**Addendum
No. 3**

Addendum Date: June 27, 2023
Project: Admin Building HVAC Replacement
DeIDOT Administration Building
SJ Project No: 19121

1
E100B **ELECTRICAL LOWER LEVEL NEW WORK PLAN - AREA B**
 SCALE: 1/8" = 1'-0"

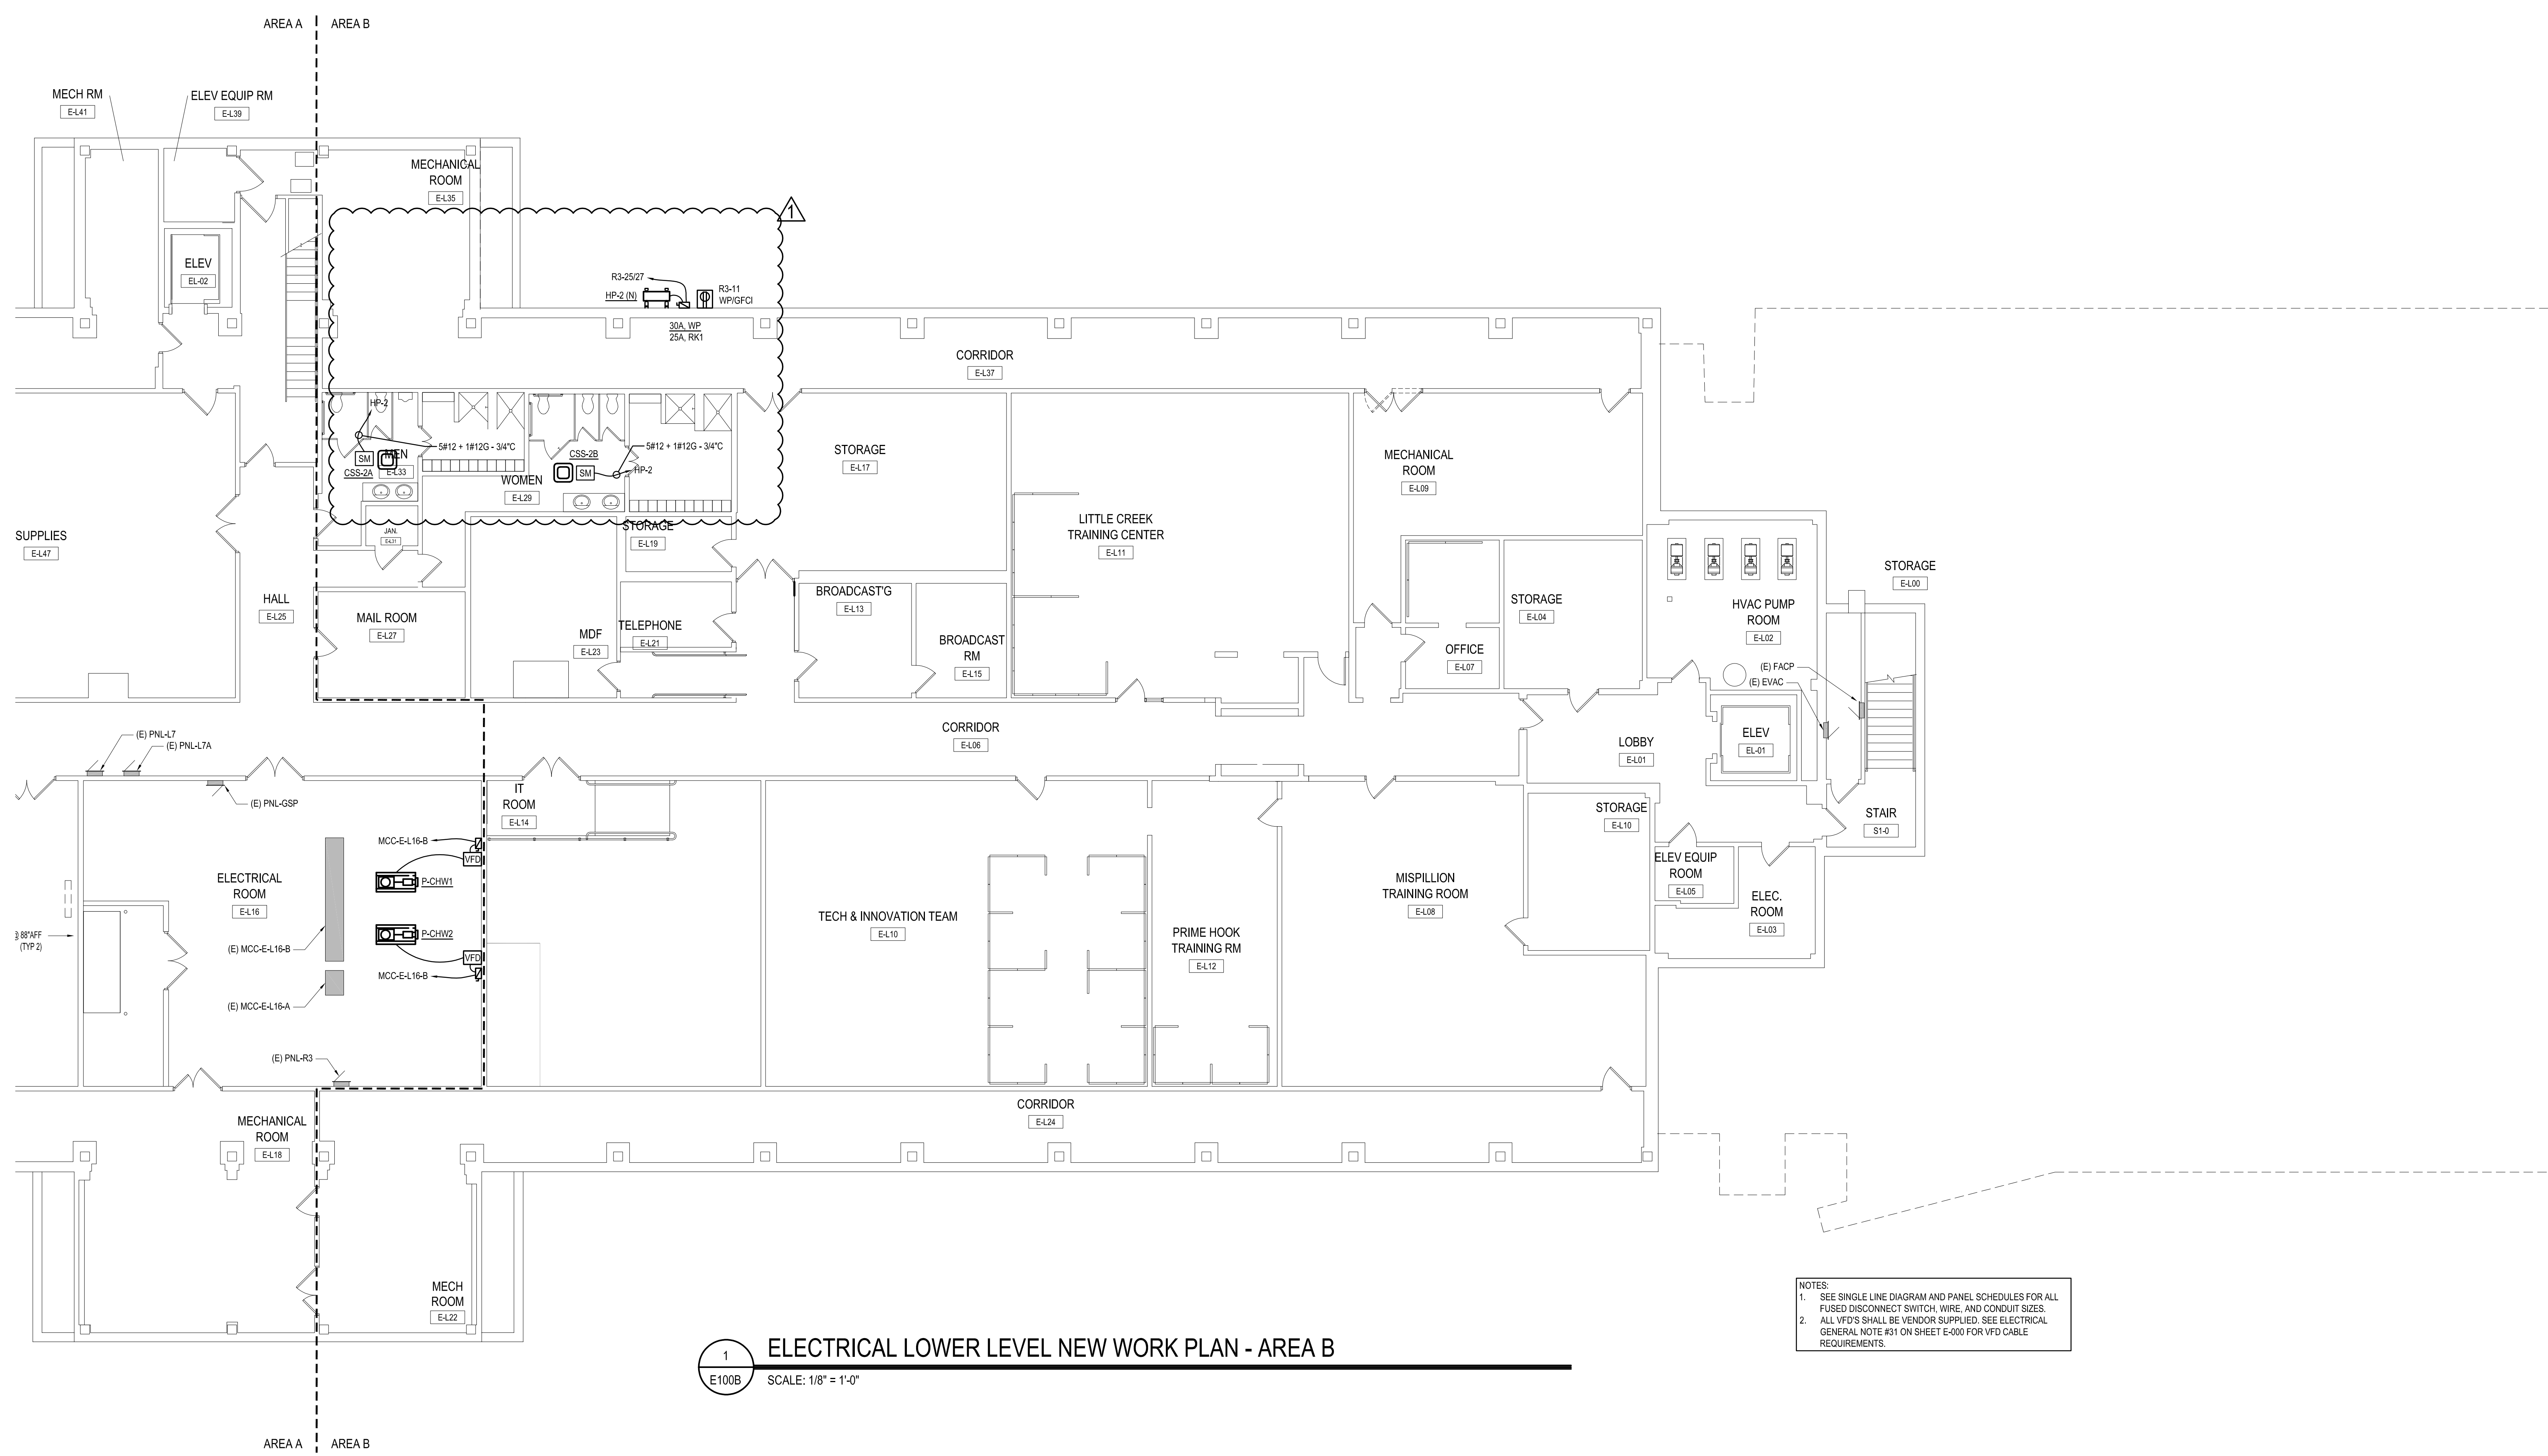
Response: All VFDs on the project are to be furnished by equipment vendor(s).
3. Question: [On] E100B, top left of page shows CSS-2A, CSS-2B but no wiring is shown. Please advise.

1. Drawing E100B – Electrical Lower Level New Work Plan – Area B
 - a. Add electrical work associated to CSS-2A, CSS-2B, and HP-2.
 - b. See attached updated Drawing E100B

Response: See attached updated drawing issued with this addendum.
4. Question: Are the duct detectors for add alt #1 new or existing to be reinstalled.
Response: The duct detectors in question are existing, to be removed and reinstalled.
